**FIRLOUGH WIND FARM, CO. MAYO  
AND  
HYDROGEN PLANT, CO. SLIGO**

**THIRD RESPONSE TO THIRD PARTY SUBMISSIONS  
AND OBSERVATIONS  
PLANNING APPLICATION REFERENCE  
ABP-317560-23**

<b>PROJECT</b>	Firlough Wind Farm and Hydrogen Plant	
<b>CLIENT / JOB NO</b>	Mercury Renewables (Carrowleagh) Limited	6129
<b>DOCUMENT TITLE</b>	Third Response to Submissions Received

Figure 1; Surface water network in the vicinity of the Hydrogen Plant; Extract from the EPA mapping service.

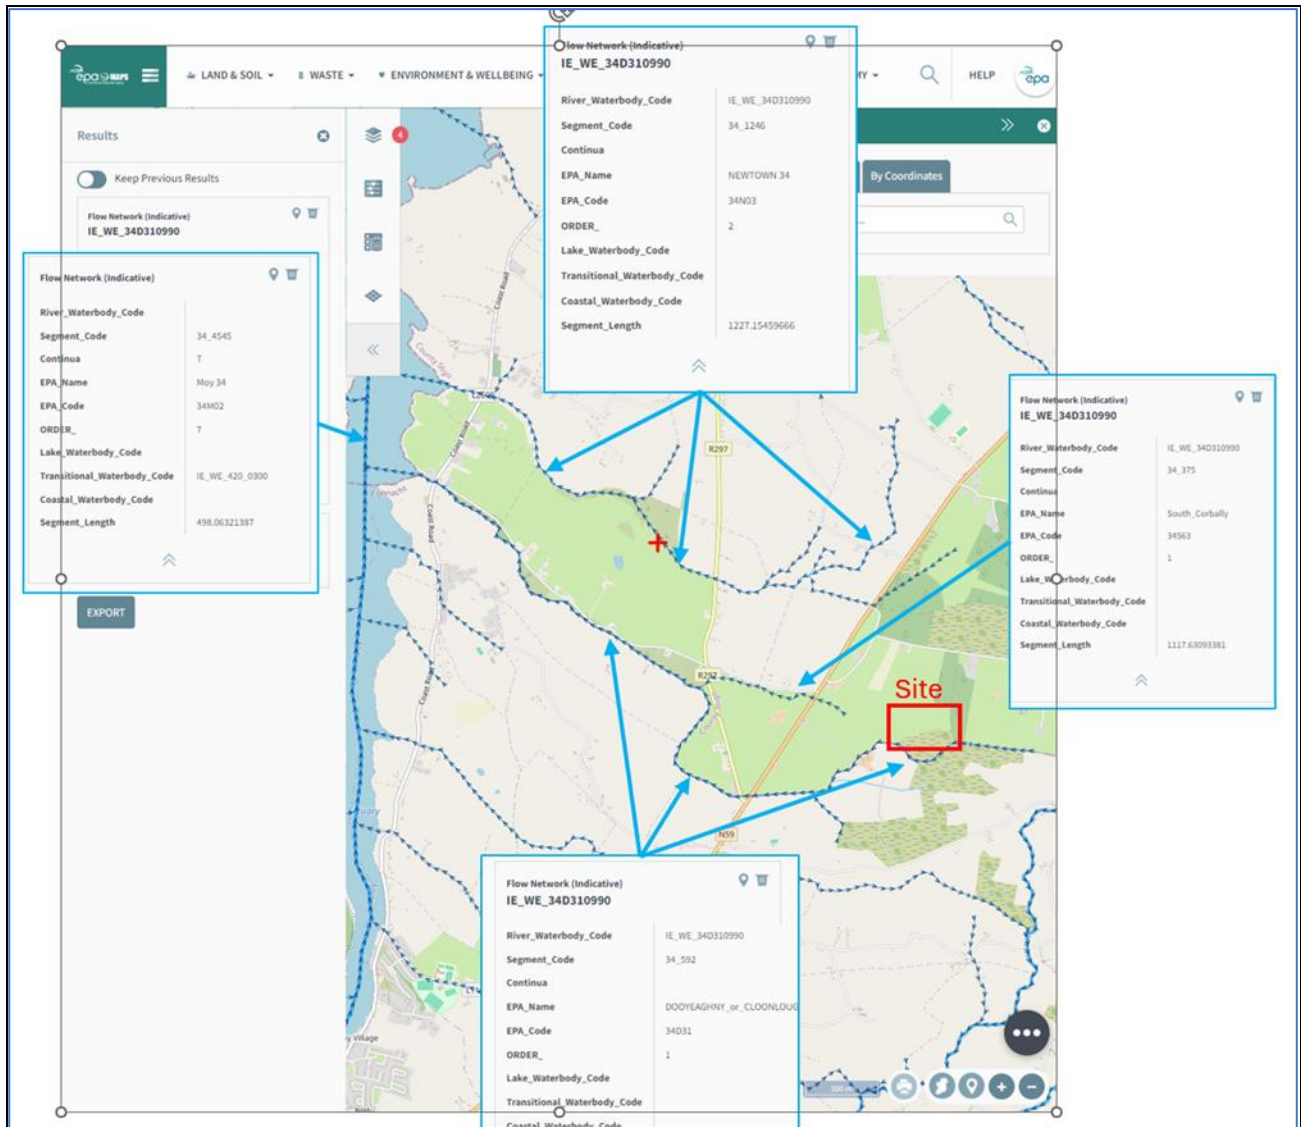
*2; IFI request consultation in relation to the ongoing flow monitoring and assimilative capacity calculations for the discharge into the Newtown River.*

The Applicant agrees to consult with the IFI in relation to ongoing flow monitoring and assimilative capacity calculations. It should be noted that the Hydrogen Plant discharges to the Dooyeaghny (or Cloonloughan) river as per the EPA. The Newtown River is located to the north of the Hydrogen Plant. See figure 1 below. The Applicant will adhere to any planning conditions in relation to monitoring at the Newtown River.

Figure 2: Fir Lough to the south of the Wind Farm Site.

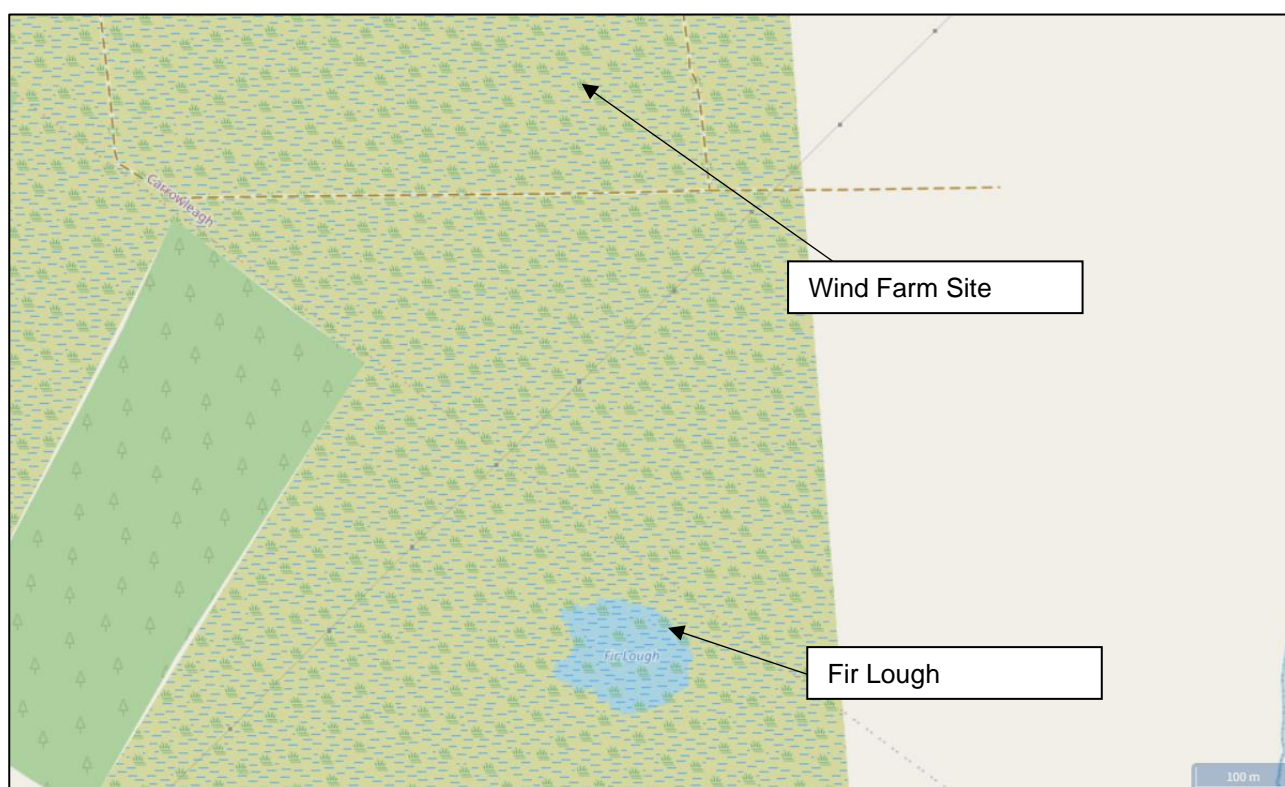
It was raised that the name of the Project "Firlough Wind Farm and Hydrogen Plant" is confusing due to the name of the bog being Carrowleagh. Carrowleagh is the Townland and formal address of the Wind Farm Site. Eirgrid requested that we change the name from Carrowleagh to avoid confusion with their nearby substation called "Carrowleagh". There is a small lake to the south of the Wind Farm Site called Fir Lough, which was used for the Project name. "Firlough" was selected by the windfarm site landowners who all live locally.
